SUBJECT: WOLF CREEK GENERATING STATION - AMENDMENT NO. 40 TO FACILITY
OPERATING LICENSE NO. NPF-42 (TAC NO. 68507)

Amendment No. 40
License No. NPF-42

SAFETY EVALUATION BY THE OFFICE OF NUCLEAR REACTOR REGULATION
RELATED TO AMENDMENT NO. 40 TO FACILITY OPERATING LICENSE NO. NPF-42
WOLF CREEK NUCLEAR OPERATING CORPORATION
WOLF CREEK GENERATING STATION
DOCKET NO. 50-482

FIGURE 3.4-2

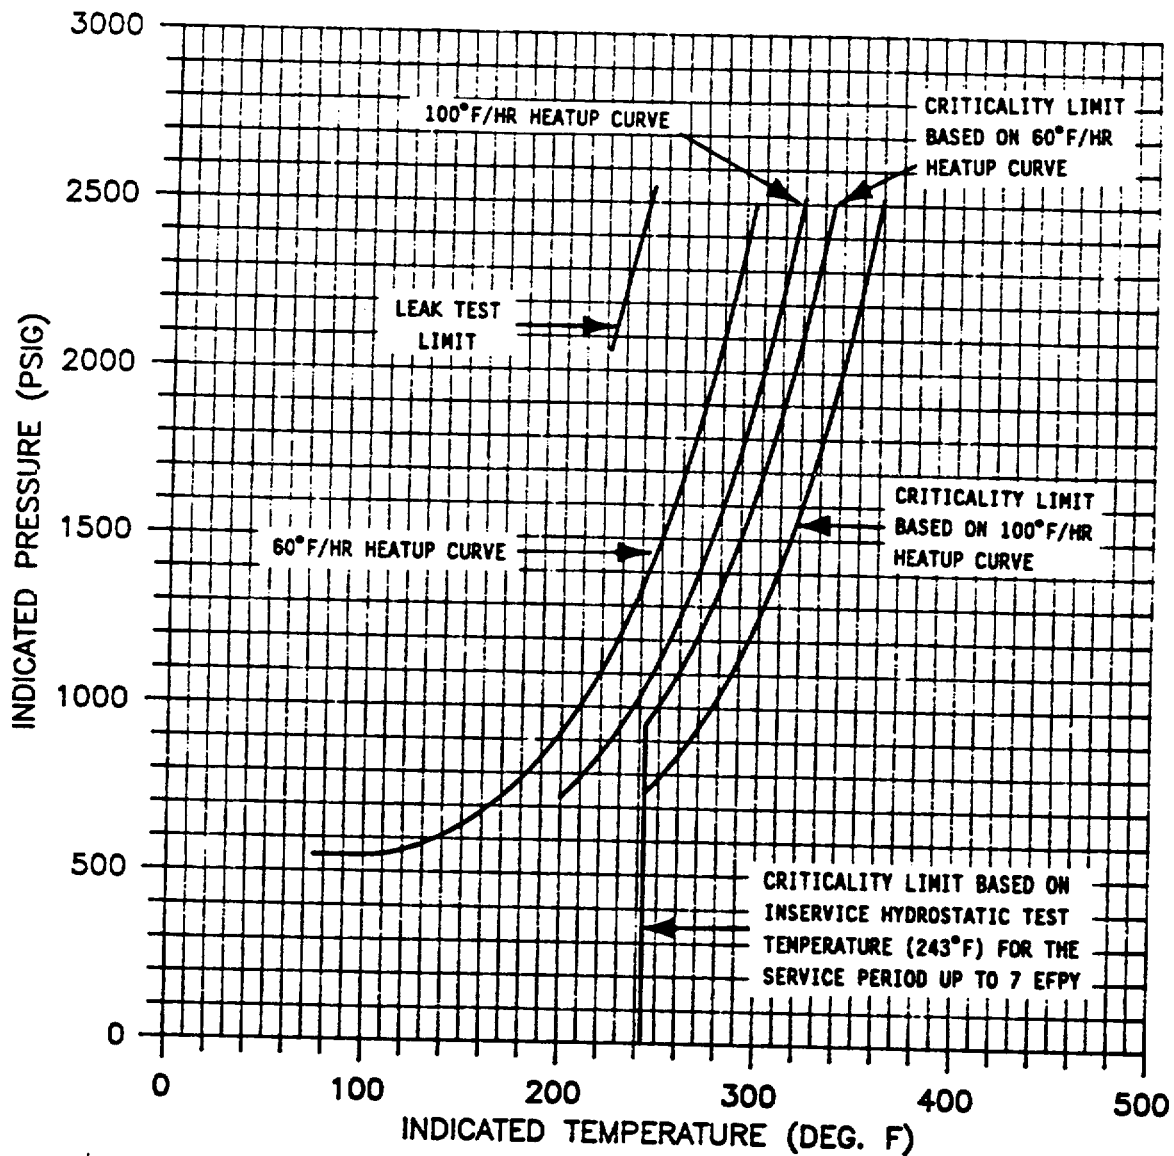
The amendment revises the heatup, cooldown and cold overpressure mitigation system power-operated relief valve setpoint pressure/temperature (P/T) limits as required by 10 CFR Part 50, Appendix H, and Technical Specification 4.4.9.1.2. The P/T limits were developed based on the data of a surveillance capsule which was withdrawn from the Wolf Creek reactor during the first refueling outage. The P/T limits are based on the irradiation damage prediction methods of Regulatory Guide 1.99, "Radiation Embrittlement of Reactor Vessel Materials," and are applicable for a period up to seven effective full power years.

Low temperature overpressure protection (LTOP) is provided by the PORVs on the pressurizer. These PORVs are set at pressures low enough to prevent violation of the 10 CFR Part 50 Appendix G heatup and cooldown curves should a RCS pressure transient occur during low temperature operations. The licensee, in its June 20, 1988, submittal, identified the most limiting overpressure transients analyzed to determine the PORV setpoints for LTOP. The PORV setpoint limits have been set by two design criteria. These are the limiting transients for mass addition and heat addition. In response to an NRC request for additional information (letter dated August 21, 1989, from D. V. Pickett, NRC to B. D. Withers, WCNOC), the licensee provided additional description of the methodology used for determining the PORV setpoints and revised Figures 3.4-2, 3.4-3, and 3.4-4 for the Wolf Creek TS.

The licensee's proposed changes in indicated temperature and PORV setpoints in the TSs are consistent with the above discussed COMS alignment temperatures and the heatup and cooldown rates identified by the updated Figures 3.4-2, 3.4-3, and 3.4-4 in TS 3.4.9. The staff finds that they are reasonably conservative and are acceptable. The staff review and approval applies to the revised Figures and Bases pages provided in the licensee's May 22, 1990, and June 6, 1990, submittals.

The licensee used the method in Regulatory Guide 1.99, Rev. 2, to calculate an adjusted RT_{NDT} of 108°F for the R2508-3 plate at 7 EFPY and 1/4T location (T is the reactor vessel thickness). The staff performed a similar calculation and verified the licensee's RT_{NDT} value to be correct (see Table 1). Substituting the RT_{NDT} of 108°F into equations in SRP 5.3.2, the staff verified that the proposed P/T limits for heatup, cooldown, criticality, and hydrotest are acceptable.

The staff concludes that the proposed WCGS P/T limits on the reactor coolant system for heatup, cooldown, leak test, and criticality are valid through 7 EFPY because the limits conform to requirements of Appendices G and H to 10 CFR Part 50. The licensee also conforms to Generic Letter 88-11 because it used the method in Regulatory Guide 1.99, Rev. 2, to calculate the reference temperature, RT_{NDT} . The proposed P/T limits may be incorporated into the WCGS TS.

FIGURE 3.4-4

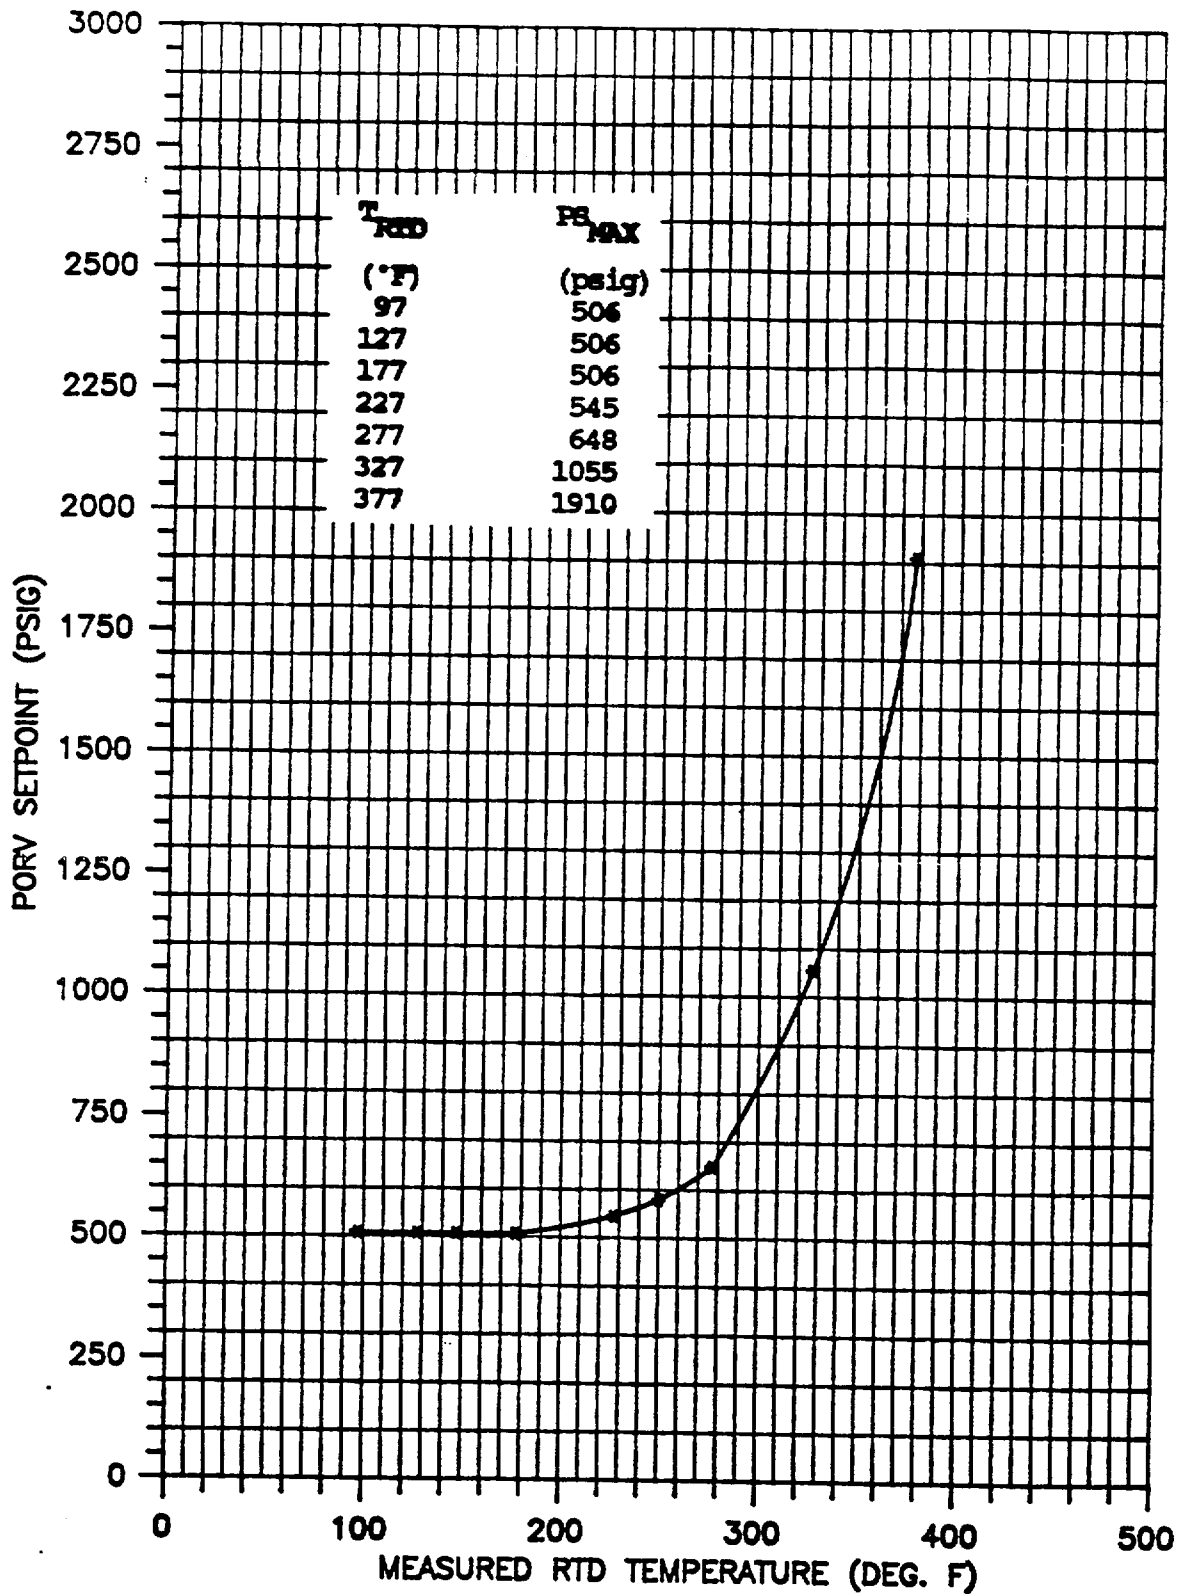
Based on the results of the most limiting LTOP transient, the licensee proposed TS PORV setpoints that are no higher than 1910 psig when the RCS average temperature is equal to 377°F. The PORV setpoints are progressively reduced at lower RCS temperatures to maintain the margin of safety required by Appendix G considerations. The combined effect of the new pressure-temperature limits is reflected in a modification to Figure 3.4-4 in the WCGS TS. The new Figure 3.4-4 presents the maximum allowed PORV setpoints as a function of RCS temperature and includes margin for possible instrument error. The modifications are based on analyses using approved methodology and are acceptable.

Based on the evaluation above, the staff concludes that the licensee's proposed TS and their associated bases are acceptable to support the updated pressure-temperature limits applicable for a period up to seven EFPY.
